# Access Compliance Report

## Public Rights-of-Way

### (Curb Ramps)

Intersection ID: 50316	Main Street: ESMERALDA_DR	Cross Street: STATESVILLE_RD	Location: SW
ADA ID: A2979A917141	Ramp Type: Perp	Initial Pass/Fail: Fail	Overall Compliance: No
Severity Score: 22.5			
Codes/Mitigation Info/Possible Solution		Field Measurements/Component Compliance

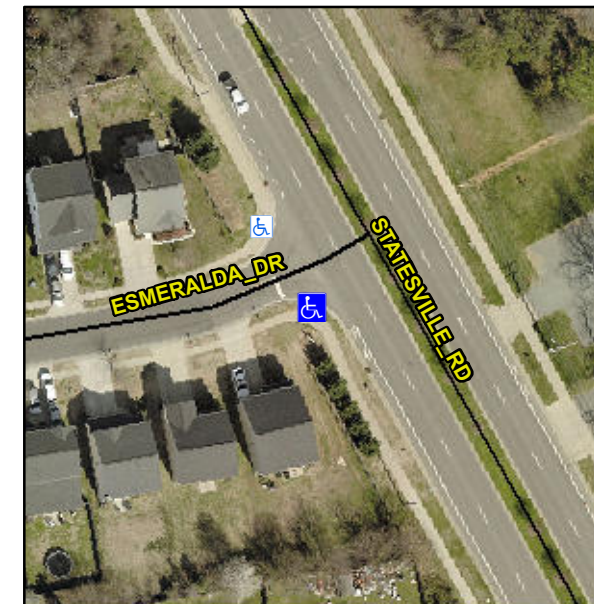
**Not Found, R304.5.1, R304.2.2, R304.5.3**

Compliance	Description	Data	Compliance	Description	Data
N/A	Ramp Length (in)	49.5	No	Ramp Slope (%)	9.0
No	Ramp Width (in)	47.0	No	Ramp XSlope (%)	2.9
N/A	Flare Type LT	N/A	N/A	Flare Type RT	N/A
N/A	Flare Slope LT (%)	N/A	N/A	Flare Slope RT (%)	N/A
N/A	Flare Traversable LT?	N/A	N/A	Flare Traversable RT?	N/A
N/A	Landing Length (in)	N/A	N/A	DWS Provided?	N/A
N/A	Landing Width (in)	N/A	N/A	DWS Contrast?	N/A
N/A	Landing Slope (%)	N/A	N/A	DWS Length (in)	N/A
N/A	Landing X Slope (%)	N/A	N/A	DWS Full Width?	N/A
N/A	Landing Curb? (Y/N)	N/A	N/A	DWS Offset (in)	N/A
N/A	Shared Landing?	N/A			
N/A	Gutter Ponding?	N/A	N/A	Gutter Slope (%)	N/A
N/A	Gutter Lip Ht (in)	N/A	N/A	Gutter X Slope (%)	N/A
N/A	Painted X Walk1?	No	N/A	Painted X Walk2?	N/A
	X Walk 1 Direction	To N		X Walk 2 Direction	N/A
N/A	X Walk 1 Width (in)	N/A	N/A	X Walk 2 Width (in)	N/A
	X Walk 1 Slope (%)	0.3		X Walk 2 Slope (%)	N/A
	X Walk 1 X Slope (%)	3.0		X Walk 2 X Slope (%)	N/A

**Remove & Replace Entire Ramp.**
